PREPARED FOR THE URBAN DESIGN COMMISSION

**Project Address:** 7-9 W. Main Street

**Application Type:** Alteration to an existing development within a DC District – Final Approval Requested

**Prepared By:** Janine Glaeser, UDC Secretary

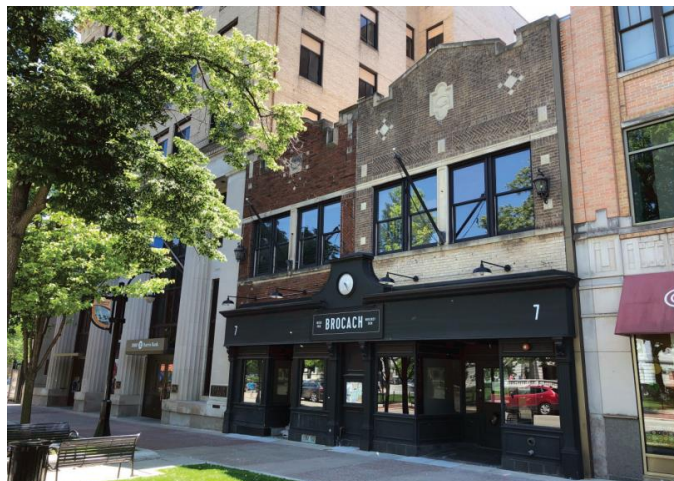
Due to staff's concerns regarding the alteration's compatibility with the design and proportions of the existing facade, the removal of upper floor architectural details, and design guideline inconsistency, the proposed modifications were not approved as a minor alteration.

Staff does NOT believe that the applicant's preferred option is consistent with the applicable design guidelines referenced below. While the other option results in fewer modifications to the upper level facade, it also changes the historic window patterning and requires modifications to surrounding detailing. Specific findings should be made in regards to the applicable standards and guidelines, as required by ordinance.

a. The size and rhythm of windows and doors in a building should respect those established by existing buildings in the area where a clear pattern exists, and the residential and/or mixed-use nature of the building. (Figure 10)

b. Existing traditional buildings should not have window openings with different sash configurations, smaller windows, or materials inappropriate to the original design. Transom windows should remain transparent/translucent.
